| Machine | TASKI swingo 350B – 1255B |

Battery plug to be disconnected during storage and charging

GTS Newsletter

2017/10E

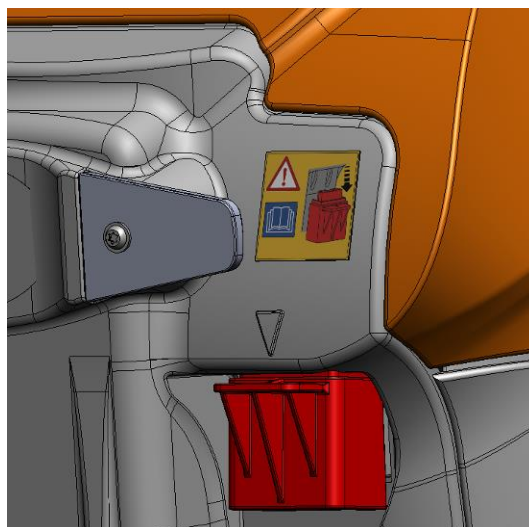
Due to safety reasons it is necessary to disconnect the battery plug from the machine during storage and charging. The machine is unsupervised during these two states and must be de-energized mandatorily.

In order that the operator does not forget about it, a sticker which is showing the plug and referring to the user manual has been placed above the disconnecting plug. In the manual it is stressed out again in which situation the machine must be de-energized mandatorily.

Please place the sticker during the next service.
